RE: Zoning Committee Staff Report File #12-101937

Tom Beach - Site plan for rebuild of Reemo Gas and Deli at 1200 Rice

Tom Beach - Site plan for Reemo gas/convenience store at 1200 Rice

RE: 1200 Rice Street Conditional Use Permit and Site Plan Review

TRUCK TURNING DIAGRAM

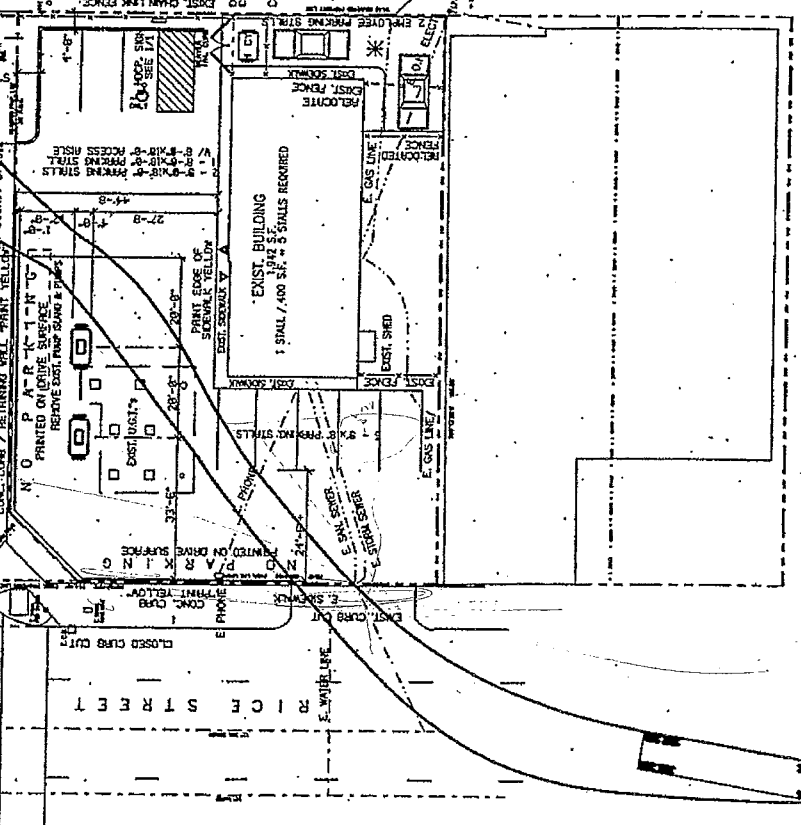
- The existing striping for Rice Street be included on the plan submittal.
- Both the WB50 and WB40 tanker trucks must be used as the design vehicle and the turning movements for both be provided for review.
- The westbound Maryland to southbound Rice turning movement include the "parking" lane on the west side of Rice. The turning movement shown in the preliminary plans did not take that area into account.
- Maneuvering room must be evaluated based on a truck origination north of Maryland as opposed to east of Rice.

TB and DK talked to John K. We agreed that John K will put WB40 maneuvers on temp plan and then DK will review. (I had suggested putting WB40 on other plans but we did not follow up on that.)

SHEET NUMBER
C1

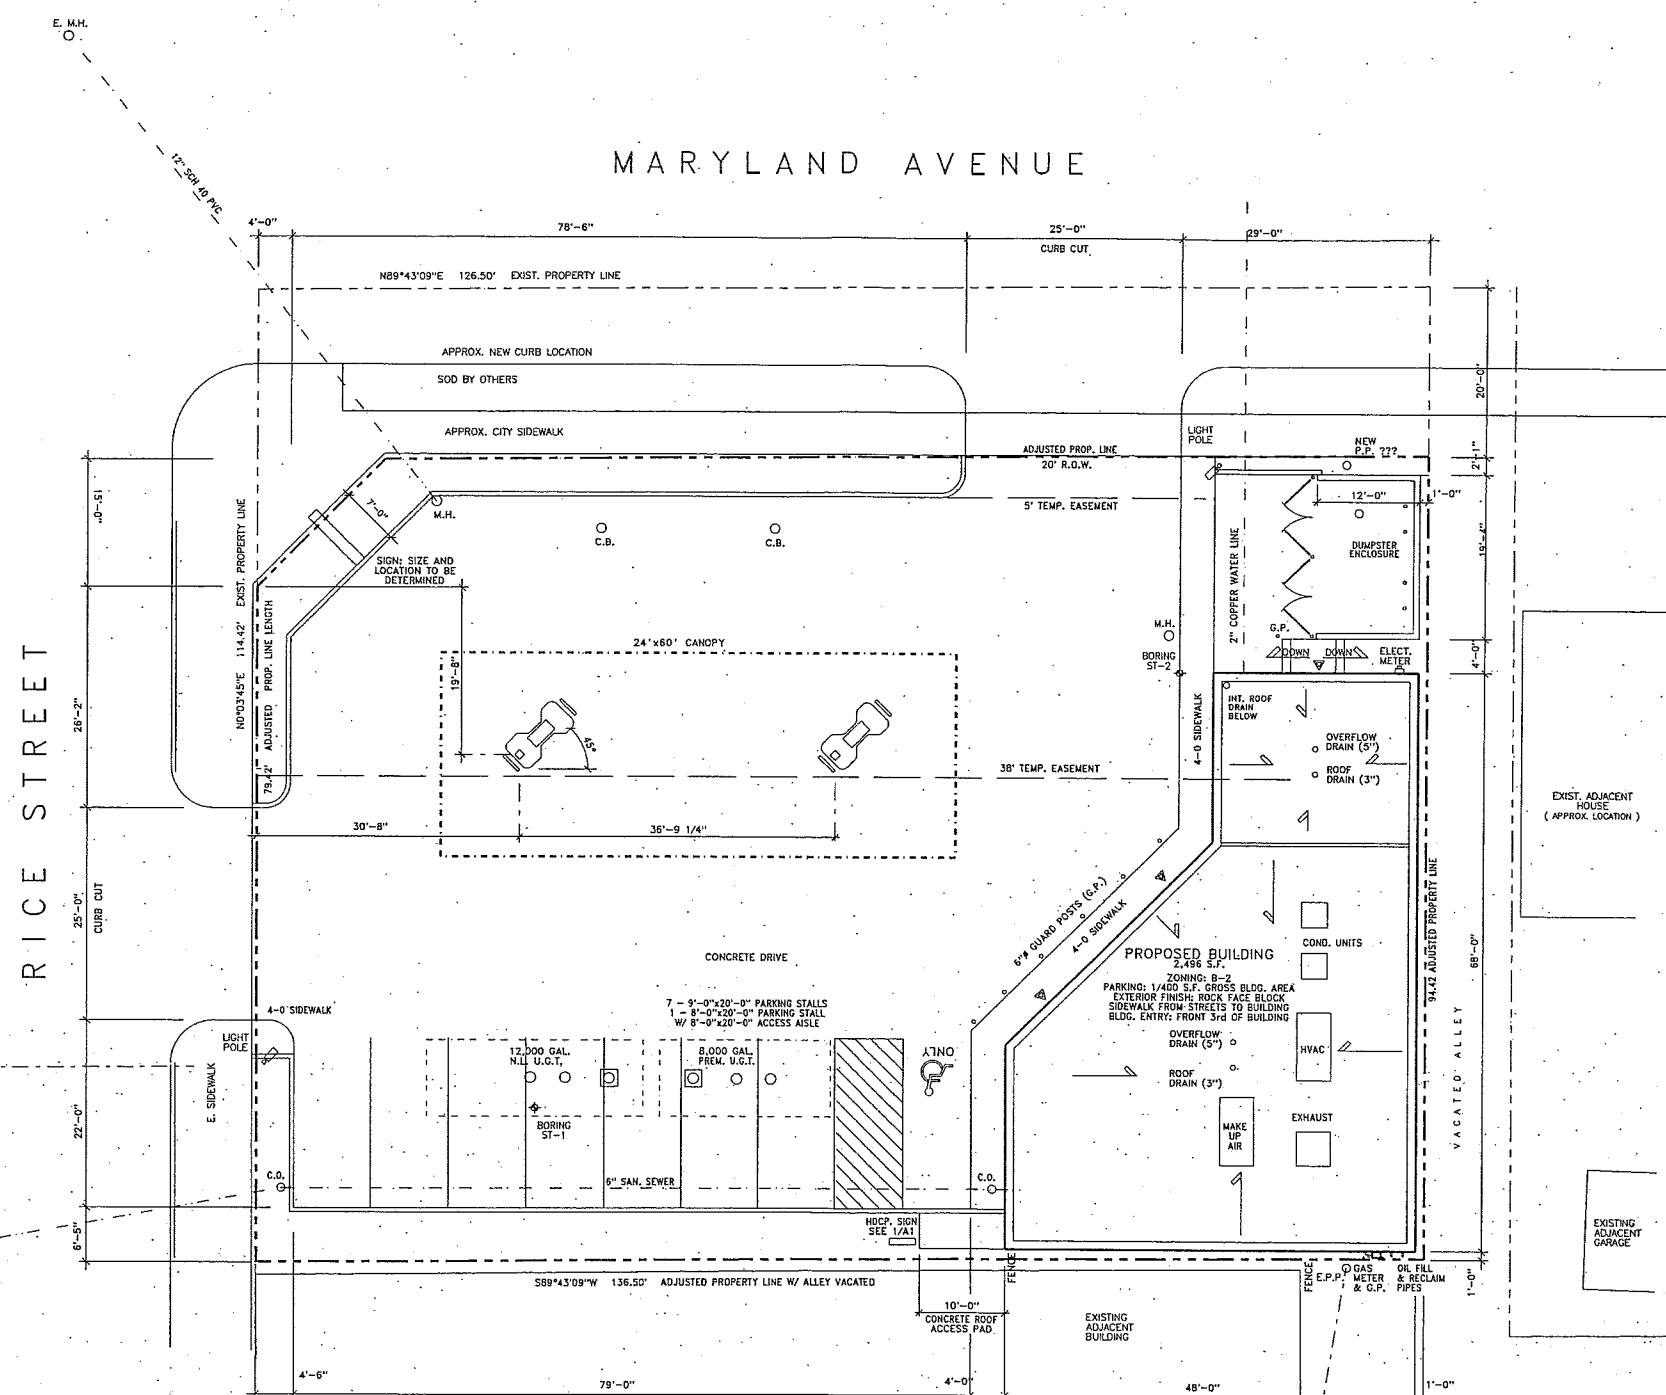
- 1) Provide the following on Plan Sheet C1 under UTILITY NOTES:
 - a) Revise Note 4 to read: "Maintain 8 feet of cover over all water services."

1) Provide the following on Plan Sheet C1 under UTILITY NOTES:

- a) Revise Note 4 to read: "Maintain 8 feet of cover over all water services."
- 2) The following work shall be performed by SPRWS on an actual cost basis. An estimate will be provided and a deposit in the amount of the estimate must be received before the work can be scheduled. Work of this type is currently being scheduled 4 - 6 weeks after payment and required signatures have been received.
 - a) Cut offs of existing unused services at the main. Excavation and restoration by contractor.
 - b) Installation of services in right of way.

Please correct these notes on Sheet C1

Note 6 – The correct name of the contact person is Long Yang.

Notes 15 and 19 – Please replace with this standard note:
